**ADDENDUM
NO. 2**

Richland Bean Blossom Schools Roofing & Mechanical Renovations
Various Schools Locations
Ellettsville, IN 47429

PROJECT: Richland Bean Blossom – Roofing & HVAC
Junior High School

DATE OF ADDENDUM: February 10, 2026

EXTERIOR ELEVATIONS

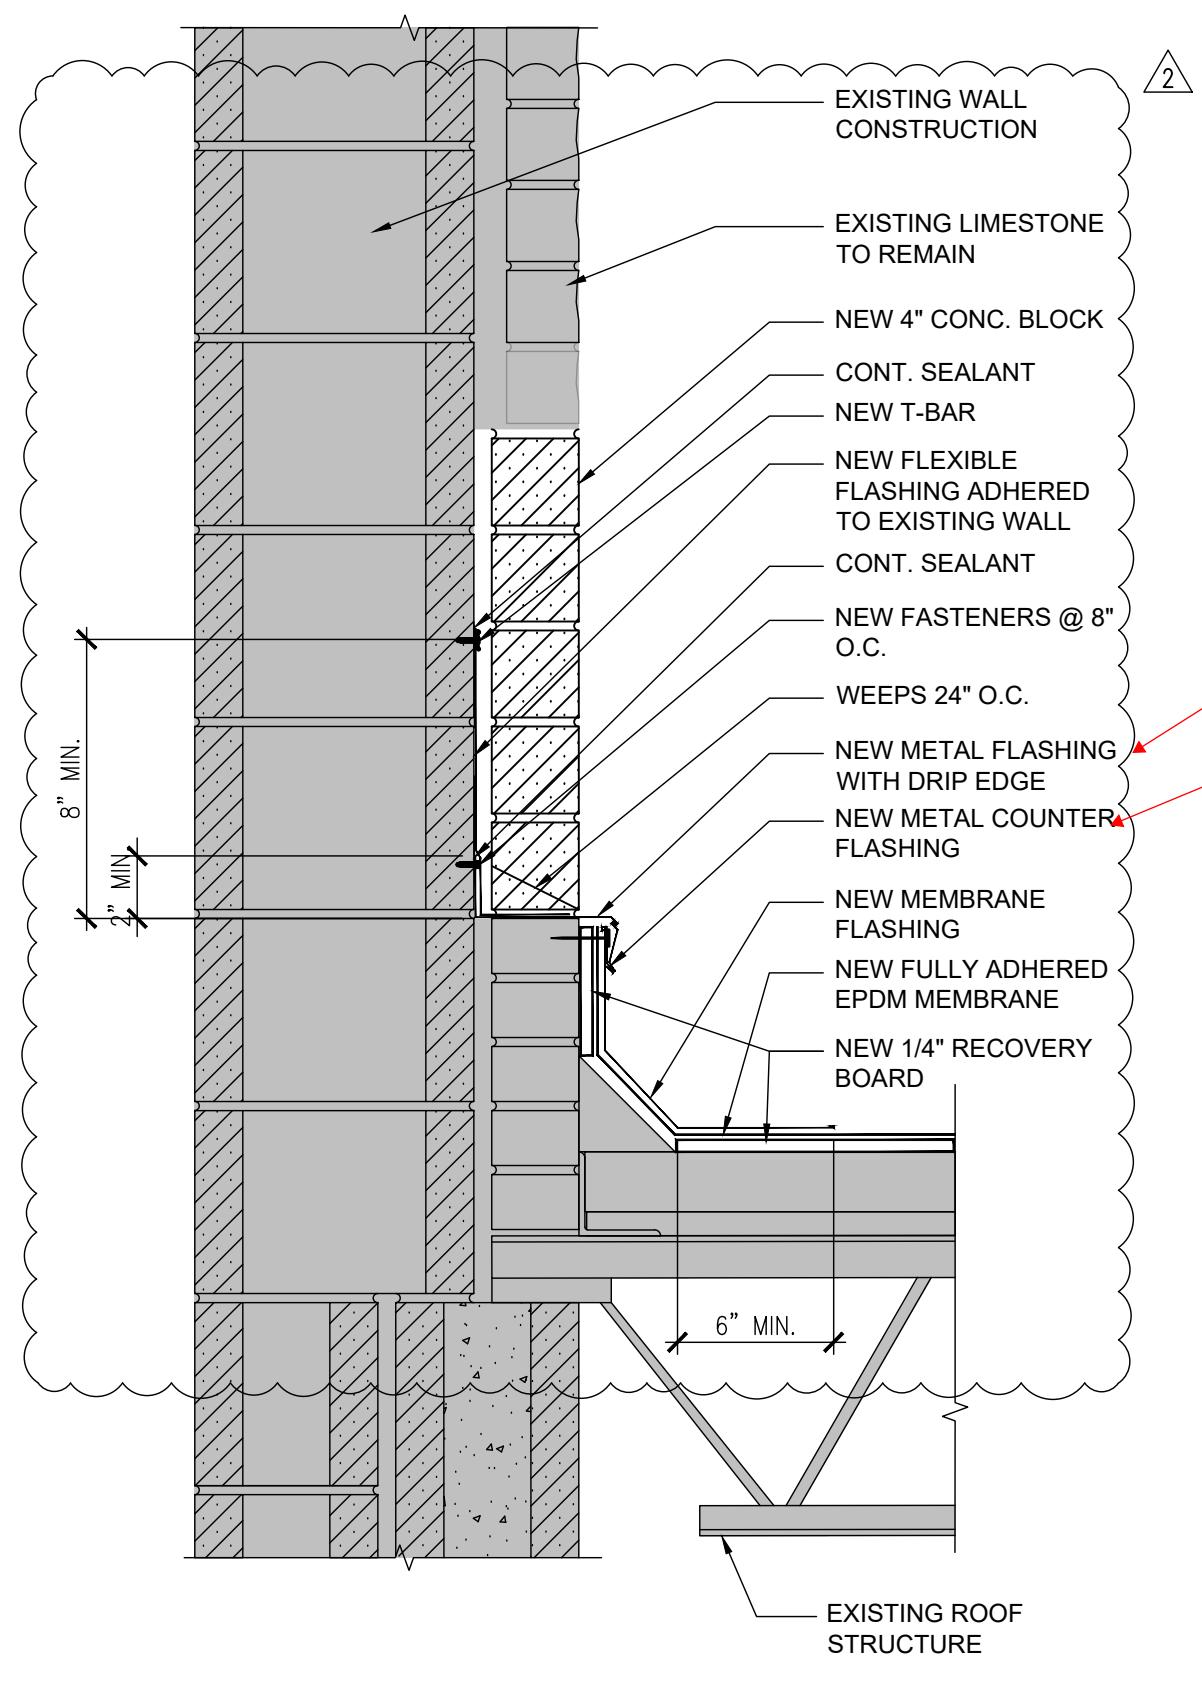
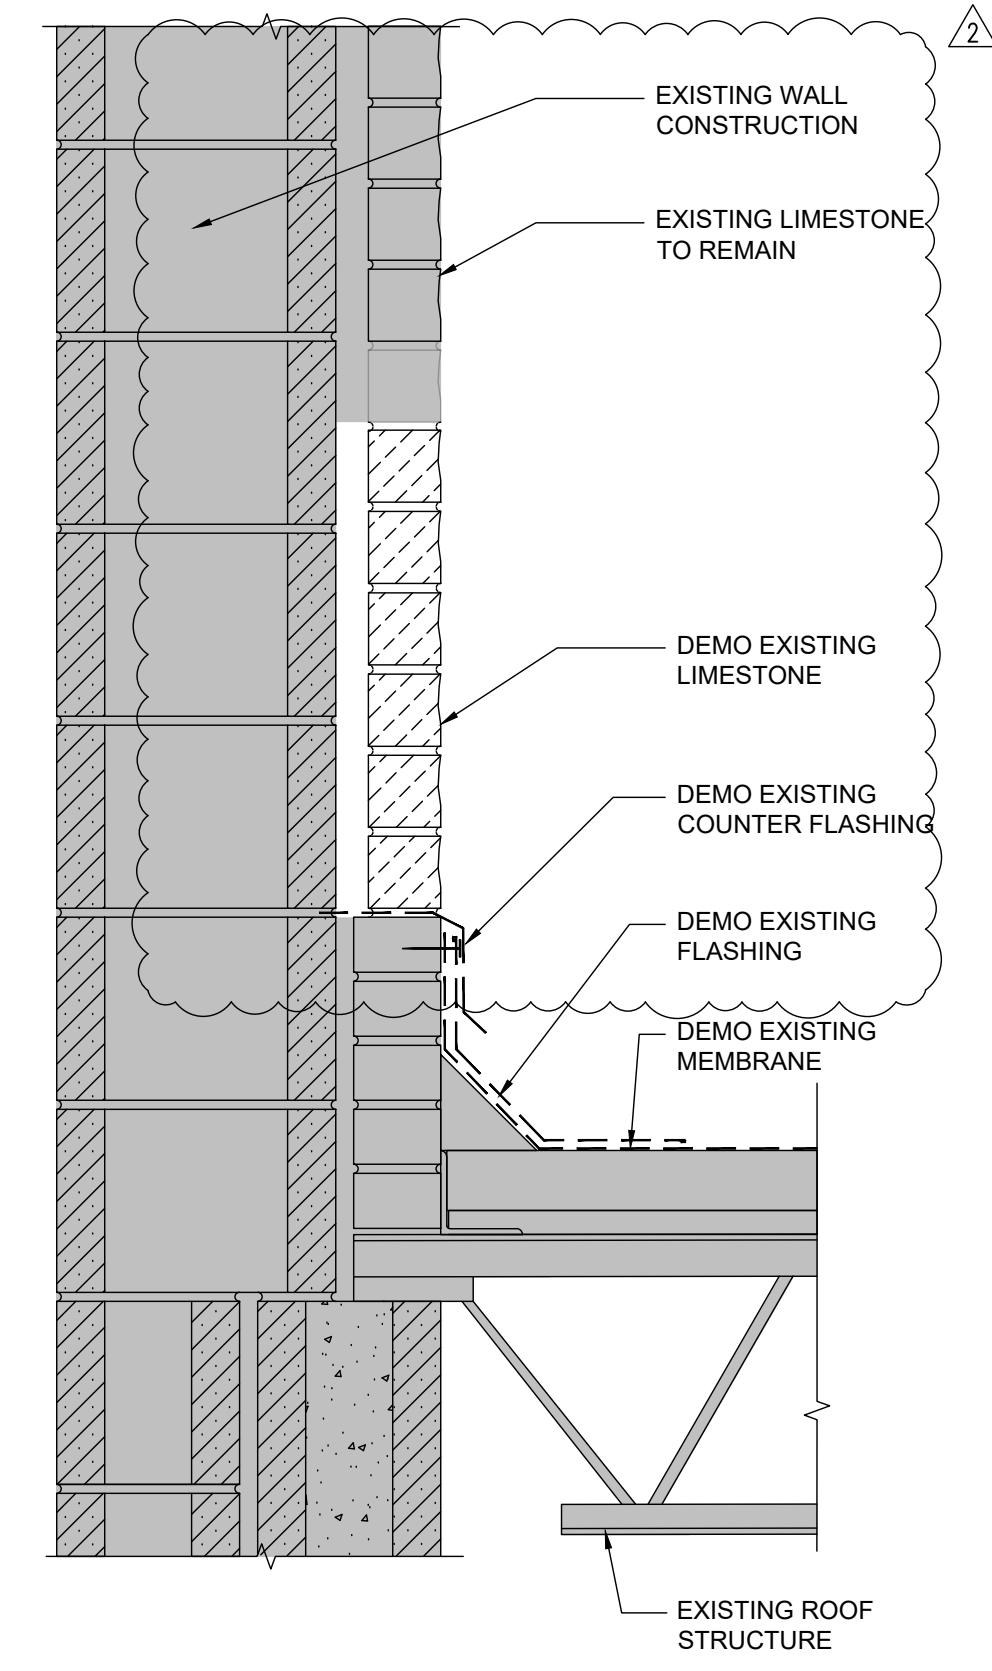
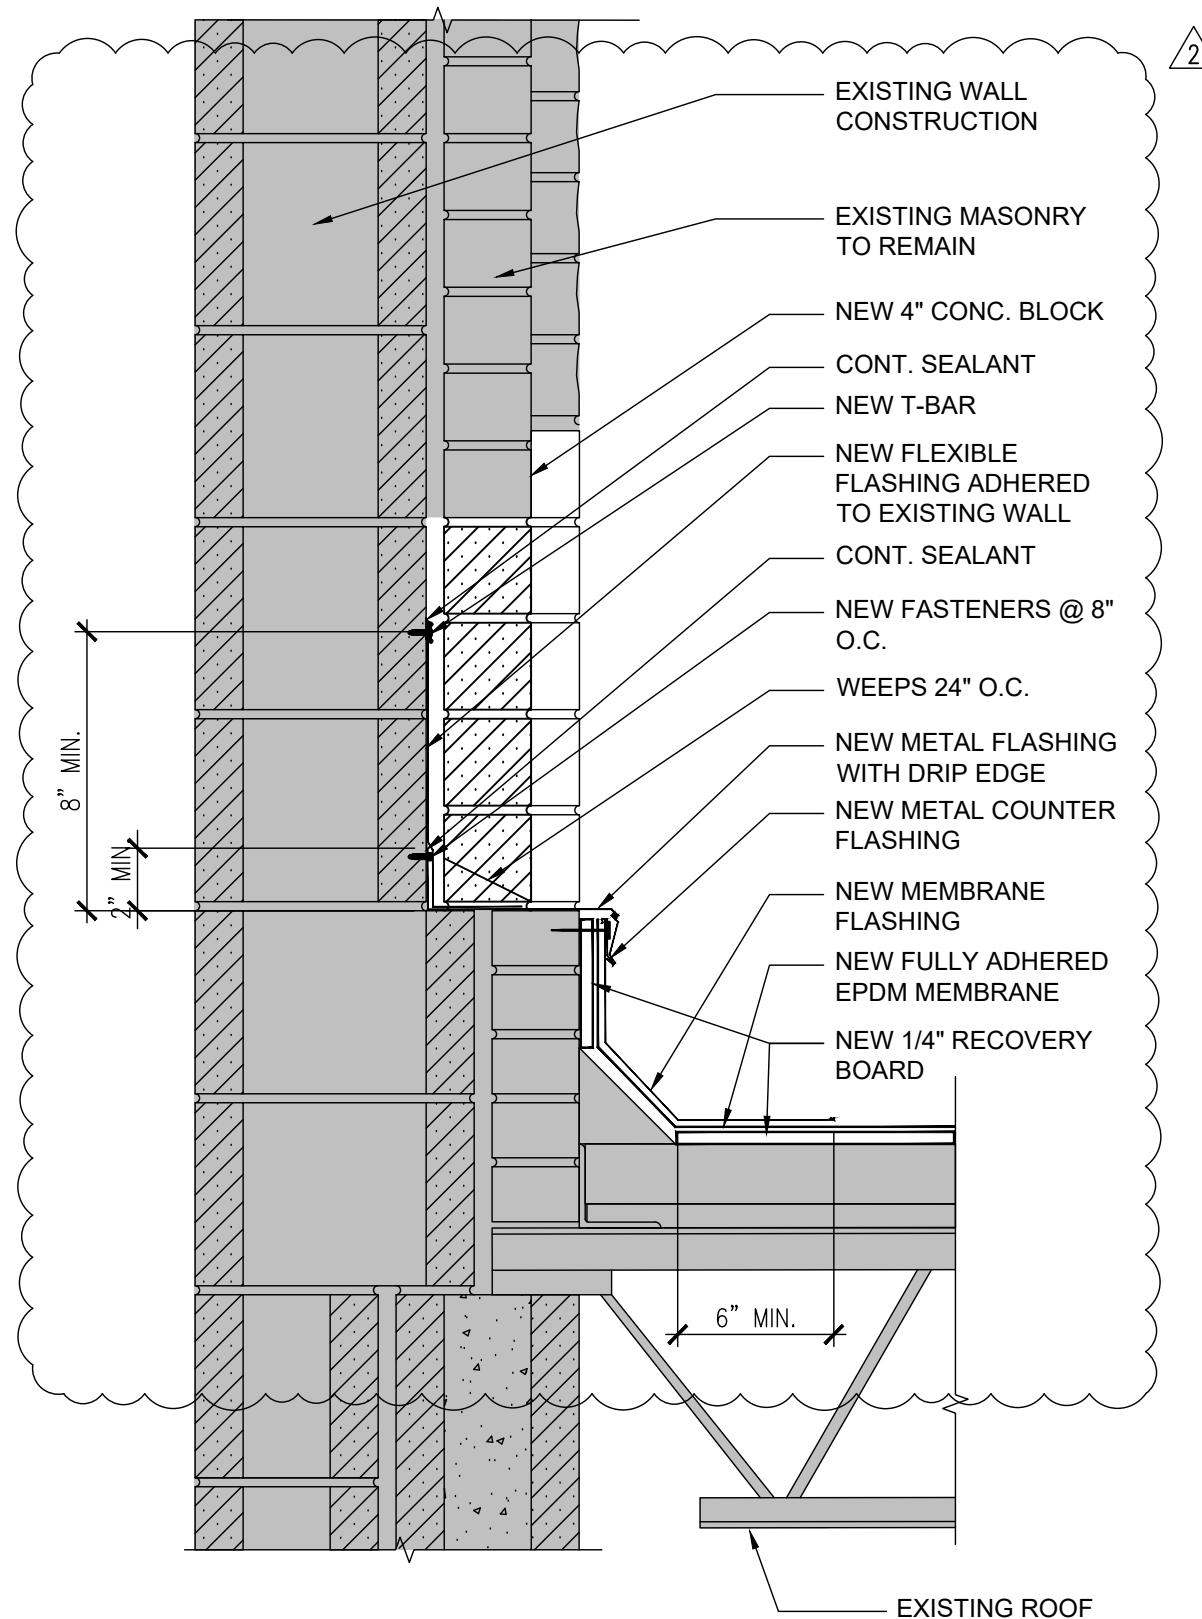
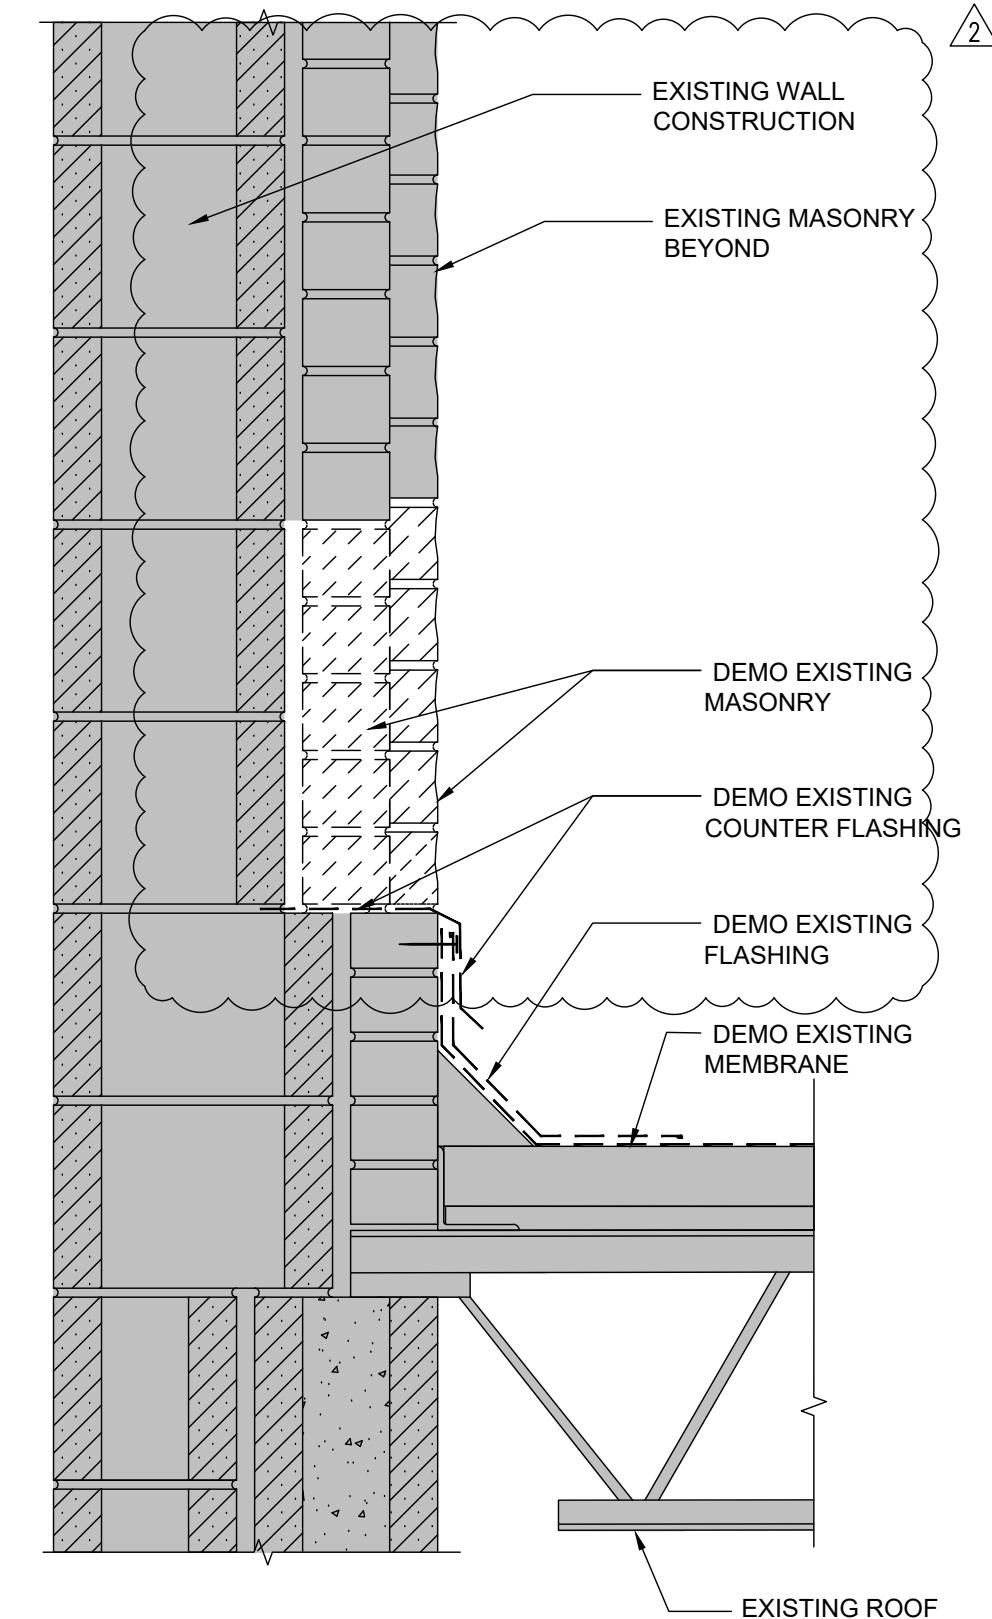
Change: revised the notes and drawings for Details 6, 7, 8, and 9 to show what we believe is actually how the existing building is built.

Change: revised the notes and drawings for Details 8 and 9 to show how the cavity flashing and new membrane roofing will be tied together.
